Value Engineering Study
Us60 RECONSTRUCTION
BALLARD & MCCRACKEN COUNTIES, KY

ITEM NUMBERS 1-115.00 & 1-115.10
VE STUDY NUMBER 201109

Final Report

December 22, 2011

Typical Section for Mainline US 60

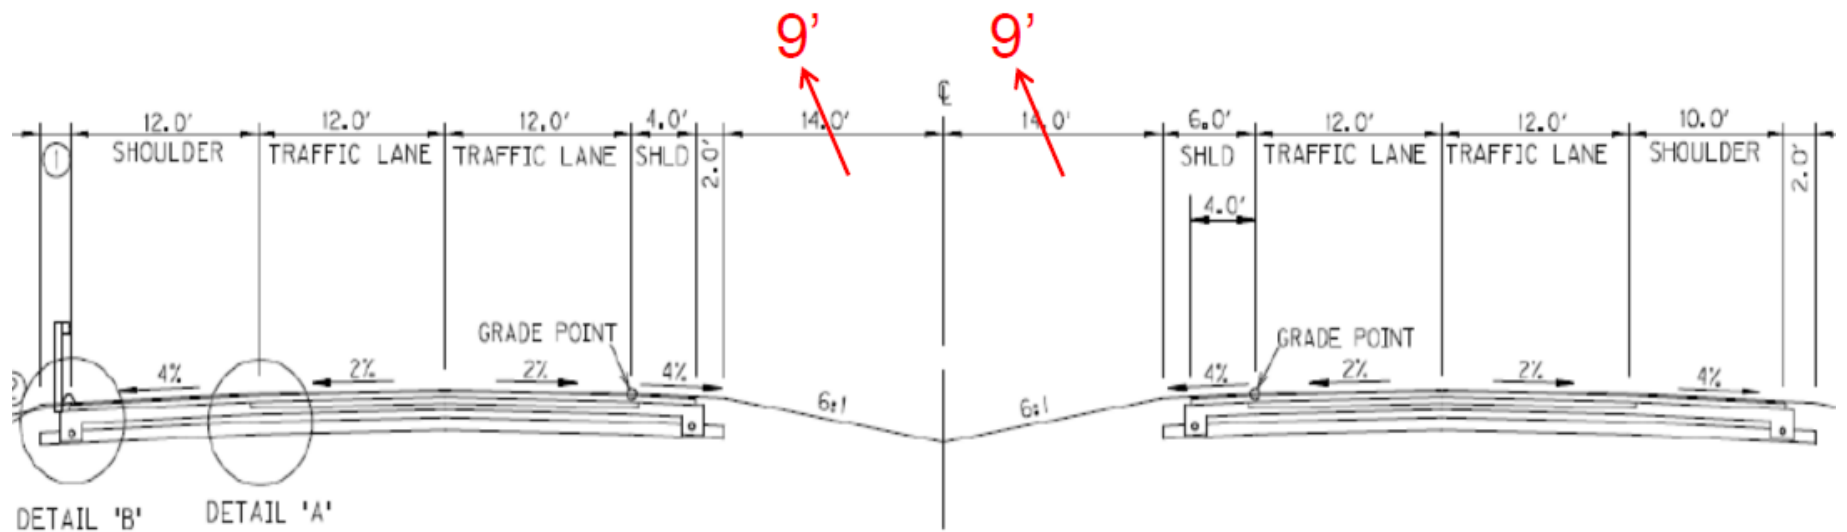
Utilize a 30 ft depressed grass median in lieu of a 40 ft depressed grass median.

The original design specifies a 40 ft depressed median throughout the corridor.

The VE Team recommends reducing depressed median section from 40 ft wide to 30 ft wide throughout mainline section. This 10 ft reduction in template width will decrease the earthwork volumes, right of way footprint and shorten the drainage structures.

The recommended change still maintains a positive separation from the travel lanes which is an improvement from the existing two lane undivided typical. Also, the narrower median will essential function the same from a traffic operation standpoint allowing space to develop left turns in the median and U-turns as needed. The change would reduce total earthwork (excavation and embankment) on the project. The narrowing of median will also result in shortening the drainage structures, decrease the right of way footprint and reduce the quantity for minor miscellaneous bid items such as seeding, clearing and grubbing, along with eliminating the need for long term maintenance cost for mowing.

Typical Section for Mainline US 60

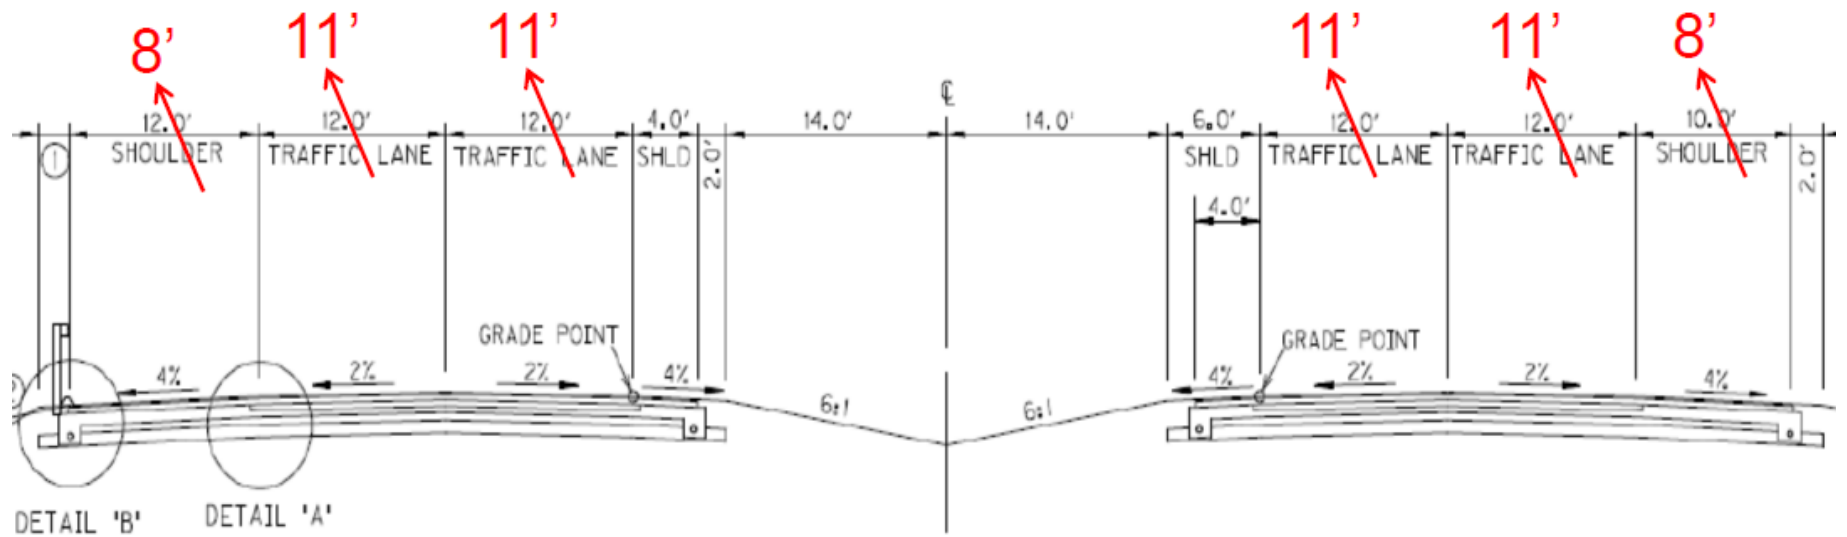
Utilize 11 ft traffic lanes and 8 ft paved outside shoulders in lieu of 12 ft traffic lanes and 10 ft paved outside shoulders.

The original design specifies 12 ft travel lanes and 10 ft paved outside shoulders.

The VE Team recommends utilizing an 11 ft traffic lane versus a 12 ft traffic lane as studies have shown that there is not an appreciable change in operation or safety by reducing the lane width from 12 ft to 11 ft. Similarly, the VE Team recommends utilizing an 8 ft paved outside shoulder width versus a 10 ft paved outside shoulder as it complies with the ASSHTO and KYTC Highway Design Manual.

The change to the reduced width of 11 ft travel lanes and 8 ft paved shoulders meet AASHTO standards and will function essentially the same from an operation standpoint given the proposed paved shoulders. FHWA recognizes this point as can be seen in the graphs on the next page.

US60 Pavement Design

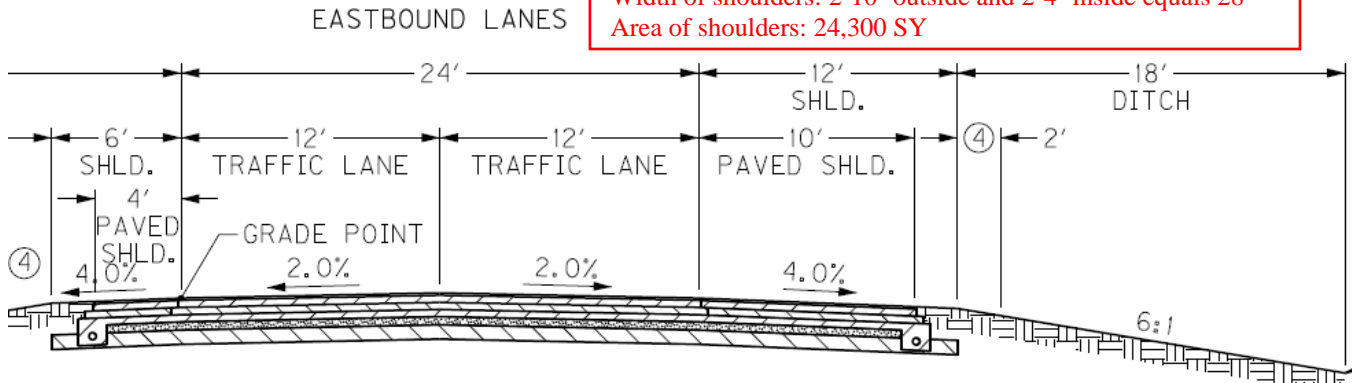
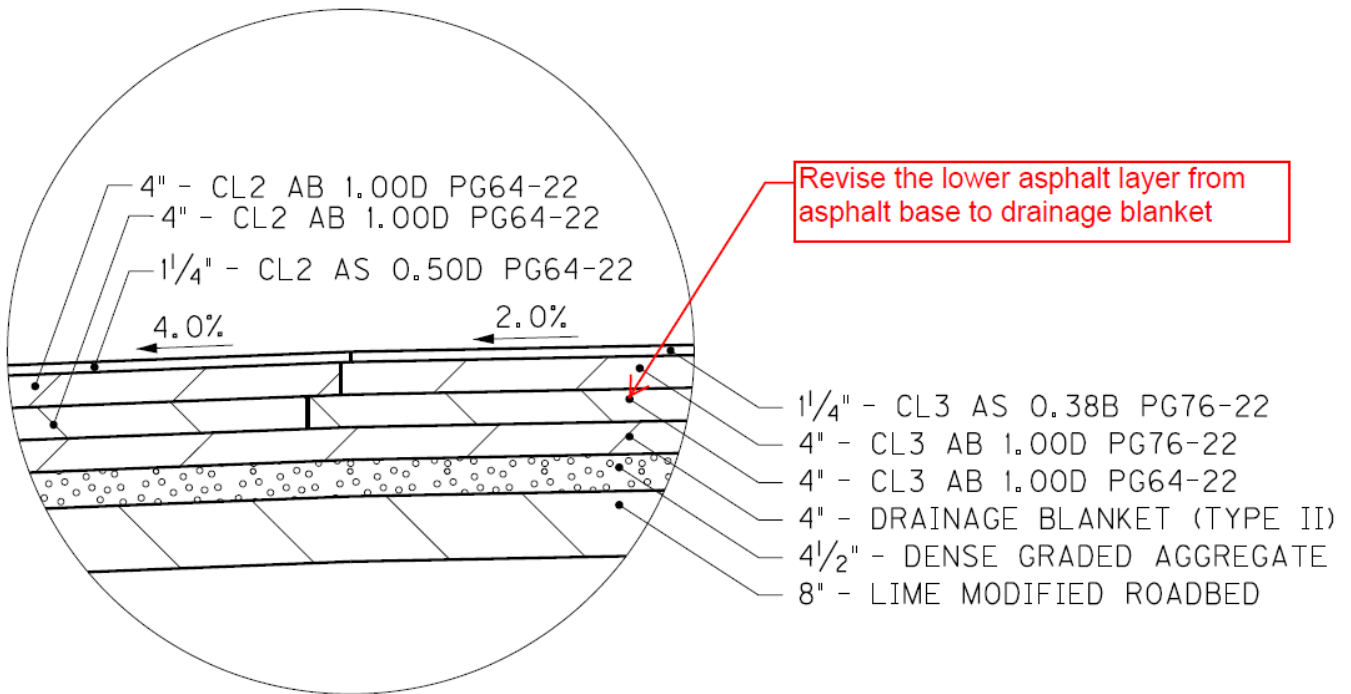
Reduce shoulder asphalt section in lieu of full depth shoulders.

The original design specifies asphalt shoulders that have the same depth as the asphalt mainline. This design is reflected in the subsequent graphics. The total asphalt depth of 9.25 inches is comprised of 1.25 inches asphalt surface with CI 2 PG 64-22 in the shoulders and CI 3 PG76-22 in the mainline, 4 inches of asphalt base with CI 2 PG64-22 in the shoulders and CI 3 PG76-22 in the mainline, and 4 inches of asphalt base with CI 2 or CI 3 PG64-22 in the shoulders and mainline.

The VE Team recommends replacing the lower 4 inches of asphalt base in the shoulders with Drainage Blanket (Type II). The graphic above provides a detail for this change and the graphic below provides an example of the depth transition between shoulder and mainline.

The asphalt depth is determined by a pavement design for the mainline. The mainline pavement design is dictated by traffic loading that applies to the mainline only. The shoulders will see a small fraction of the mainline traffic loading. Therefore the pavement design and asphalt depth for the shoulders should more closely match with what is actually required. The lower asphalt base is replaced with drainage blanket instead of DGA so that the function of the drainage blanket is not compromised.

Revise the lower asphalt layer from asphalt base to drainage blanket

Example of Hot Mix Asphalt (HMA) Depth Transition Between Shoulder and Mainline

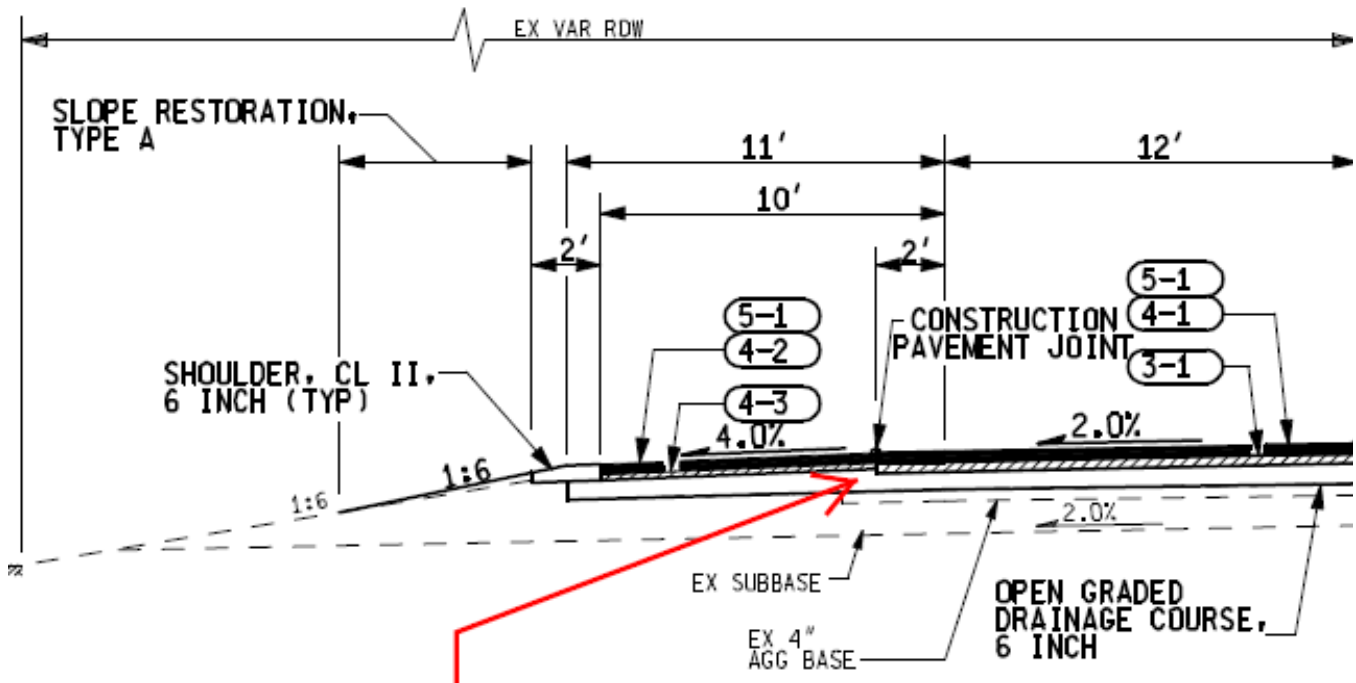
HMA depth transitions from 5.5" in shoulder to 7" in mainline

Recommended Pavement Design for Approaches from Item No. 1-115.10

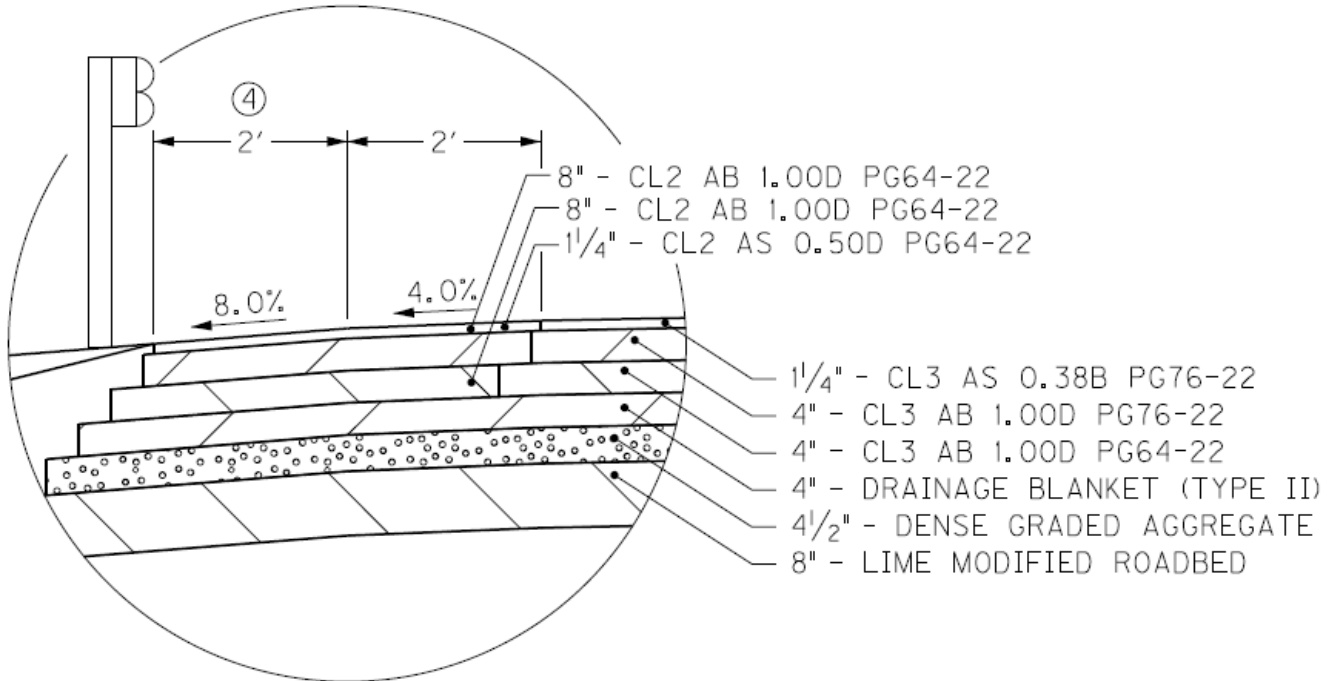
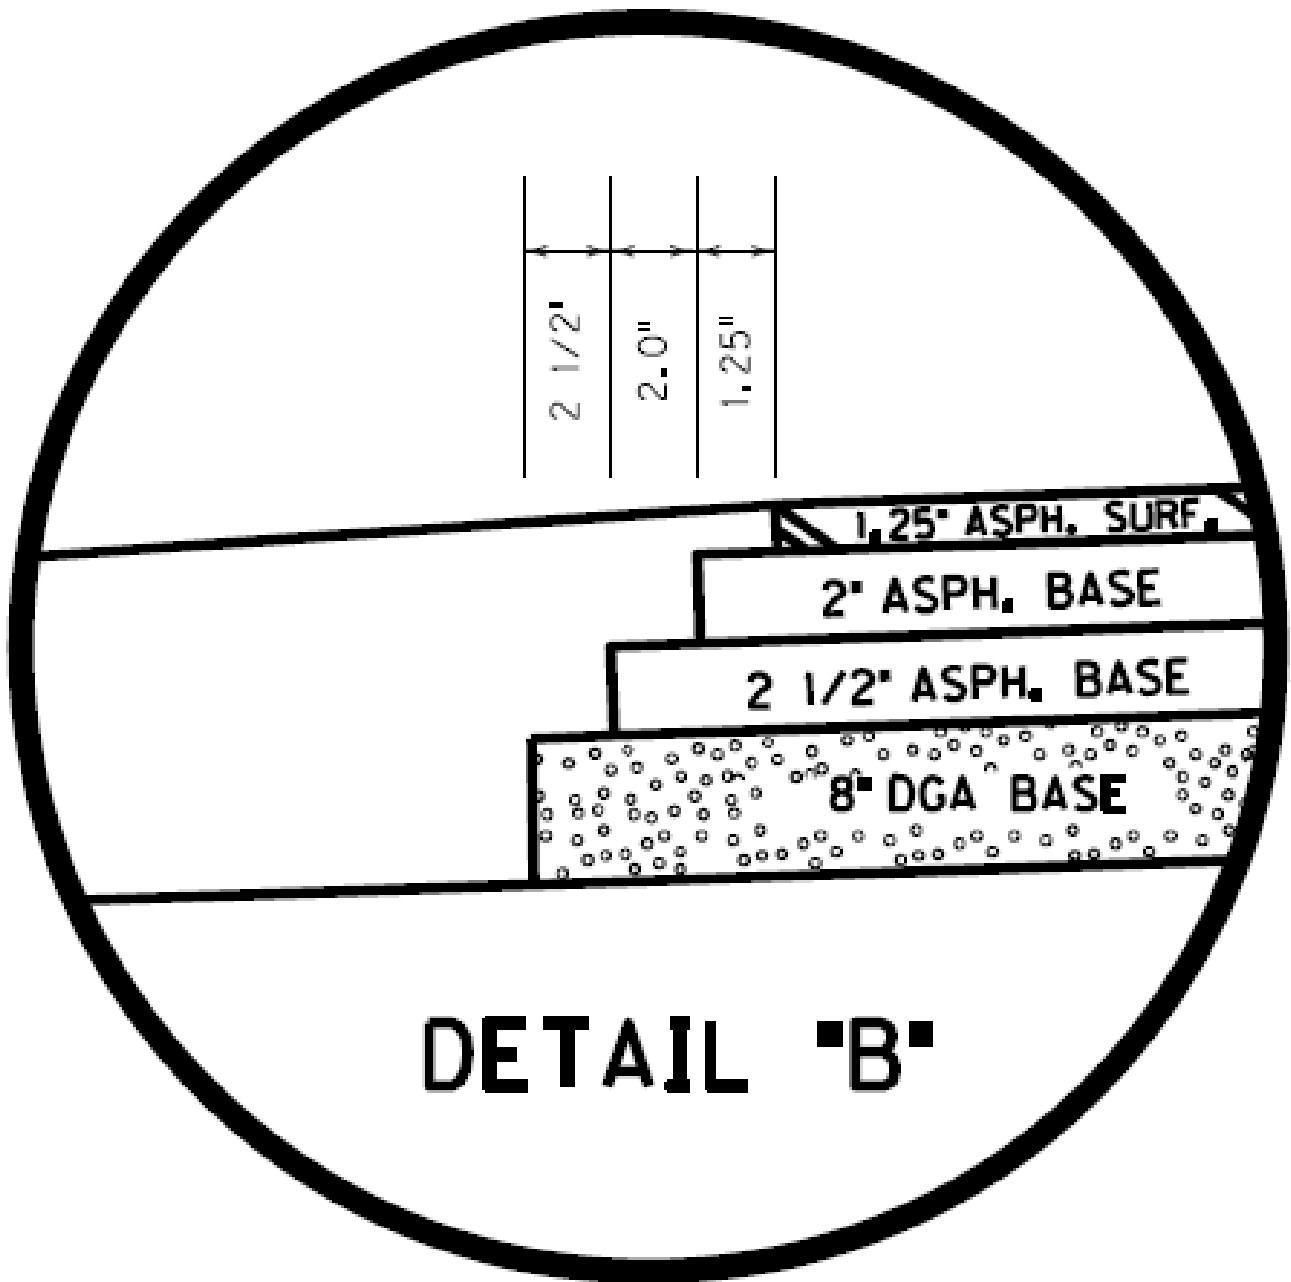
Where intersecting roads are to be reconstructed, reduce the asphalt section from 9.25 inches to 5.75 inches where applicable.

The original design specifies asphalt approaches that have the same depth as the asphalt mainline. This design is reflected in the subsequent graphics. The total asphalt depth of 9.25 inches is comprised of 1.25 inches asphalt surface with CI 2 PG 64-22 in the shoulders and CI 3 PG76-22 in the approach lanes, 4 inches of asphalt base with CI 2 PG64-22 in the shoulders and CI 3 PG76-22 in the approach lanes, and 4 inches of asphalt base with CI 2 or CI 3 PG64-22 in the shoulders and approach lanes.

The VE Team recommends an asphalt approach design that is appropriate for the low traffic volumes on the approach roads and drives. The asphalt approach design that is recommended is shown below. This asphalt approach design is taken from the Item No. 1-115.10 plans and already applies to a number of the approaches on that project.

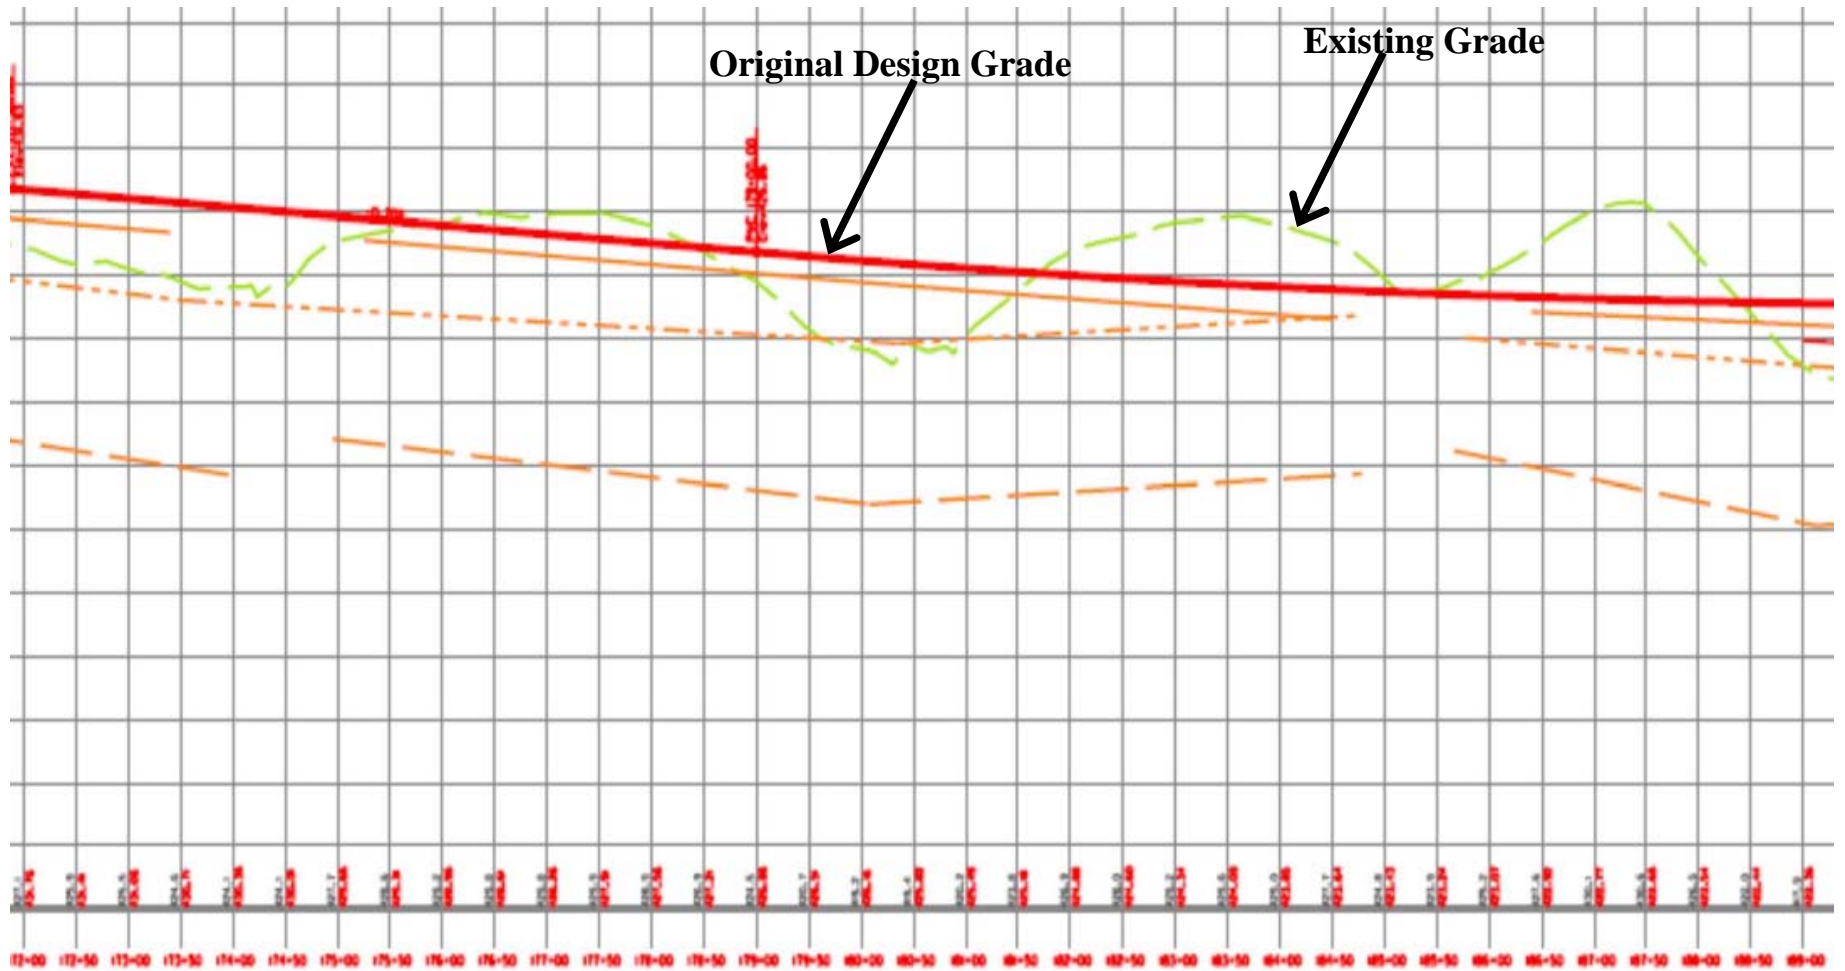
The balancing of earthwork is desirable on most projects. This project has the potential for earthwork balancing by applying slight modifications to the road profile and therefore earthwork balancing should be a goal. The roadway excavation item will have a reduced unit price if excavation removal is reduced.
